Appl. No.: 10/526,593
Reply to Office Action of: 08/03/2006

Amendments to the Drawings:

FIG. 3

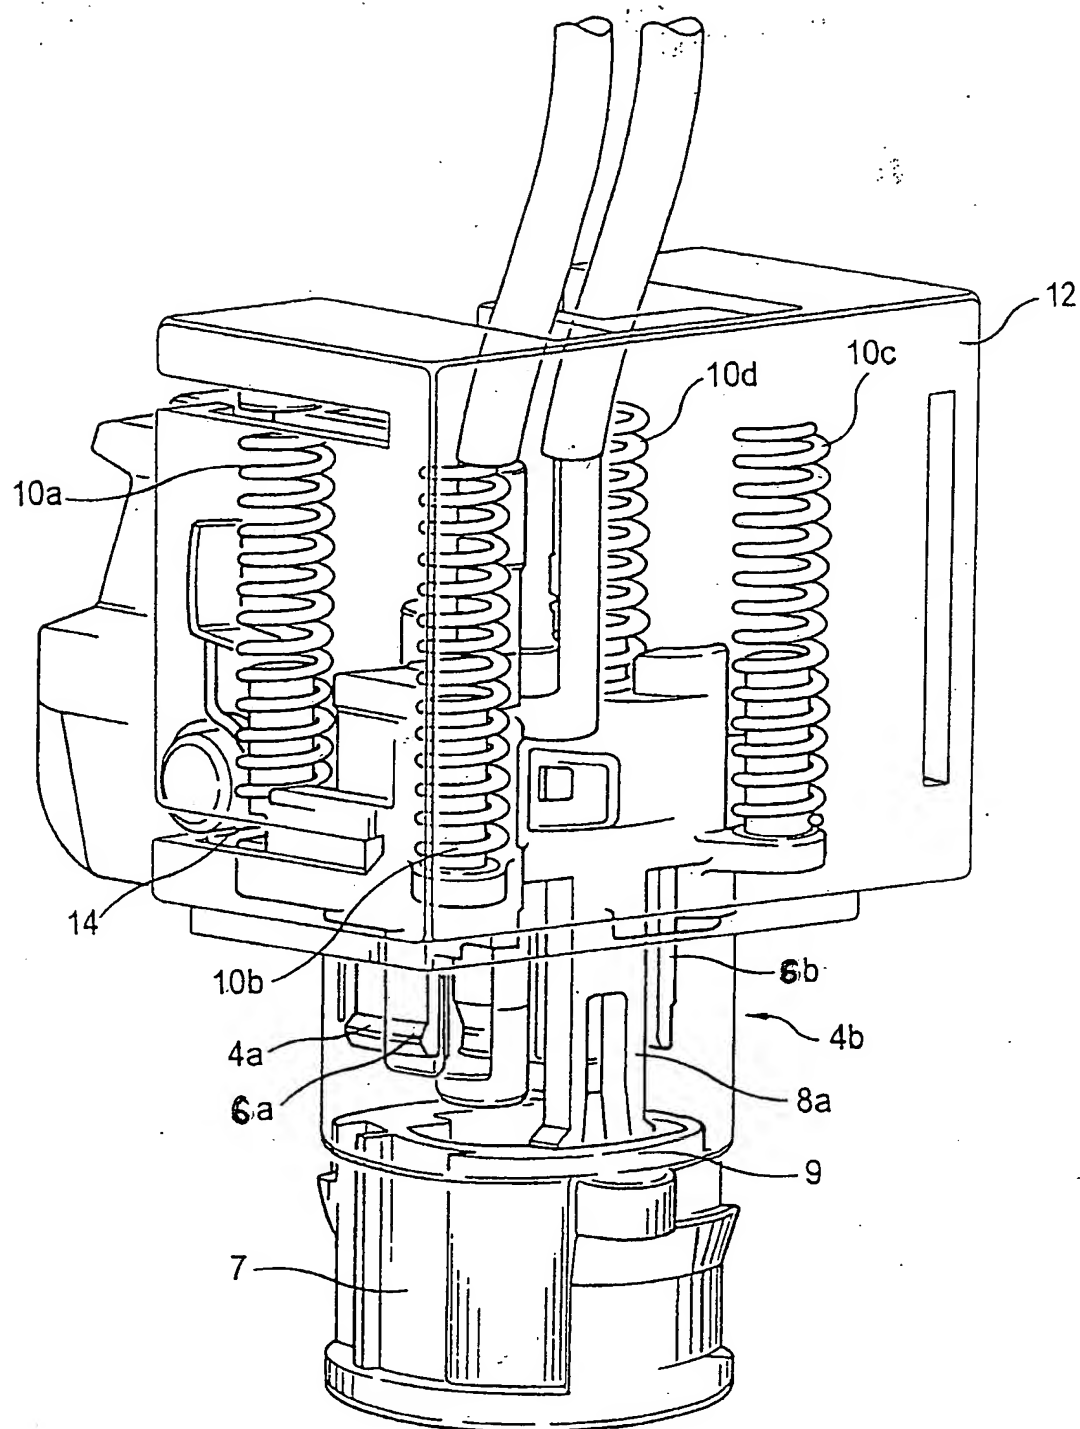
The attached sheet of drawings includes changes to Fig. 3

"8b" has been corrected to --6b--.

"8a" (first occurrence) has been corrected to --6a--.
